We are pleased to return to you with amendments to the Macadam Character Statement. These edits are in response to requests from both Commissioner Fritz and Commissioner Hardesty, as well as the South Portland Neighborhood Association (SPNA). On November 13, staff met with the SPNA to discuss revisions to the Macadam Character Statement, and on November 24, staff received additional comments from Commissioner Hardesty. These amendments are detailed (using track changes) in a draft of the revised Macadam Character Statement (Attachment A).

Attachment A.

REVISED MACADAM CHARACTER STATEMENT <u>TEXT</u> BACKGROUND: HISTORY AND EXISTING CONDITIONS

REVISED MACADAM CHARACTER STATEMENT MAP

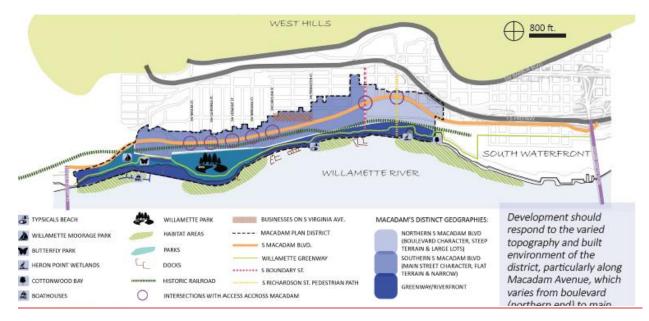
- 4. Add an intersection symbol at the intersection of S Richardson Street and S Macadam Blvd. The SPNA requested a change to the map, to identify an existing pedestrian trail along S Richardson that also provides access across S Macadam Avenue. It is not meant have a substantive effect on development but is intended to support Citywide Design Guideline 01 by identifying where and how development can support and recognize community assets, like the riverfront and trails. They signal that development at these intersections, and along the corresponding streets, should provide access for pedestrians to help strengthen east/west connections within the district.
